UNITED STATES PATENT AND TRADEMARK OFFICE

APPLICATION NO.	FILING DATE	FIRST NAMED INVENTOR	ATTORNEY DOCKET NO.	CONFIRMATION NO.
10/807,370	03/24/2004	John J. O'Mahony	3659-86	3960

Office Action Summary

DETAILED ACTION

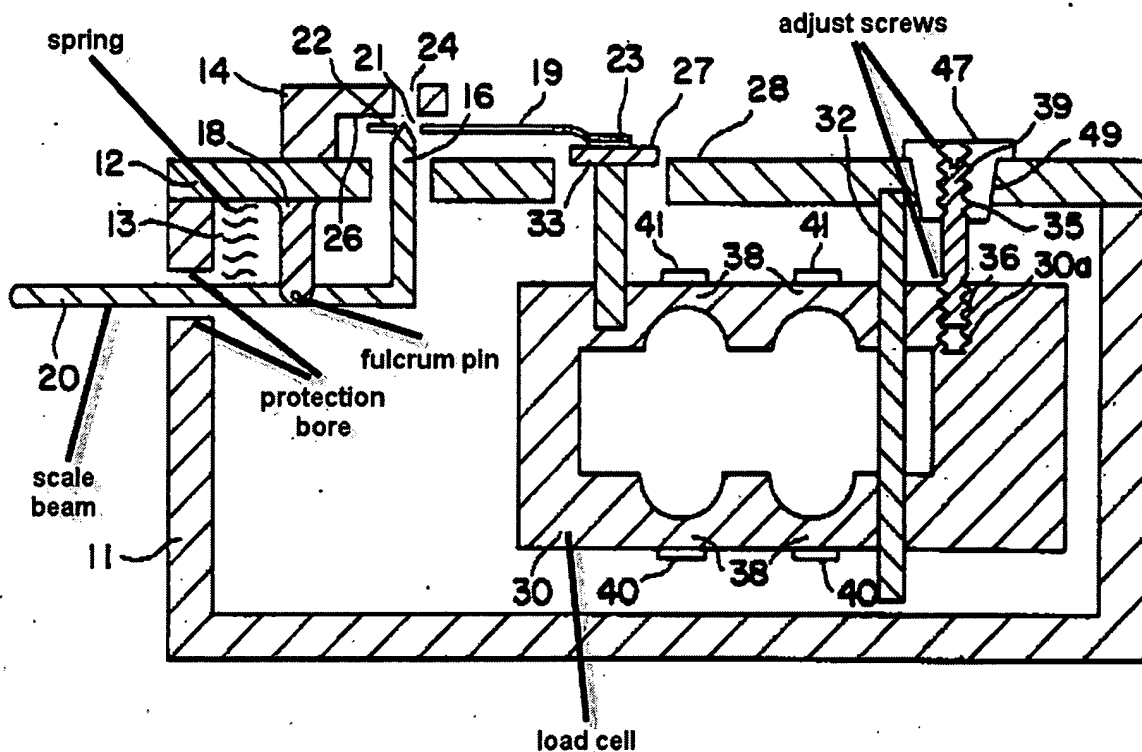
10. With respect to claim 1, Castle discloses a weight scale comprising: a load cell attachable to a support housing (30 fig. 1 and picture I. provide below); a spring coupled to the load cell to apply a force to the load cell (13 fig. 1 and picture I. provide below); a scale beam connected to the spring and at a proximal end connectable to the support housing (20 fig. 1 and picture I. provide below), and an overload protection bore comprising an aperture through which extends said beam and said aperture having at least one edge in a path of said beam (fig. 1 and picture I. provide below), wherein said edge terminates said path and the beam reaches a maximum rated load position in the path before the edge (follows from the fact that it is attached to a spring and the movement is limited by the protection bore.)

11. With respect to claim 2, Castle discloses a weight scale as in claim 1 (see 102 rejection above) wherein the proximal end of the beam is connected to the support housing via a fulcrum pin and the beam pivots with respect to the housing (18 fig. 1 and picture I. provide above.)
12. With respect to claim 3, Castle discloses a weight scale as in claim 1 wherein the spring is connected to a distal end of the beam (20 fig. 1 and picture I provide above.)
13. With respect to claim 4, Castle discloses a weight scale as in claim 1 wherein the bore aperture has edges on all sides of said beam, and said edges prevent excessive displacement of the beam (see picture I. provided above.)

14. With respect to claim 5, Castle discloses a weight scale as in claim 1 further comprising an adjustable attachment between the spring and at least one of the beam and load cell, wherein said adjustable attachment establishes an unloaded position of the beam (36 and 39 fig. 1 and see picture I. provided above.)

15. With respect to claim 6, Castle discloses a weight scale as in claim 1 wherein said overload protection bore comprises an aperture through which extends said beam and said aperture having at least one edge in a path of said beam (see picture I. provided above.), wherein said edge terminates said path and the beam has maximum rated load position in the path before the edge (the opening necessarily functions as a load bar, with a maximum rated load position because it limits the distance the beam will move against the spring, 13 fig. 1.)
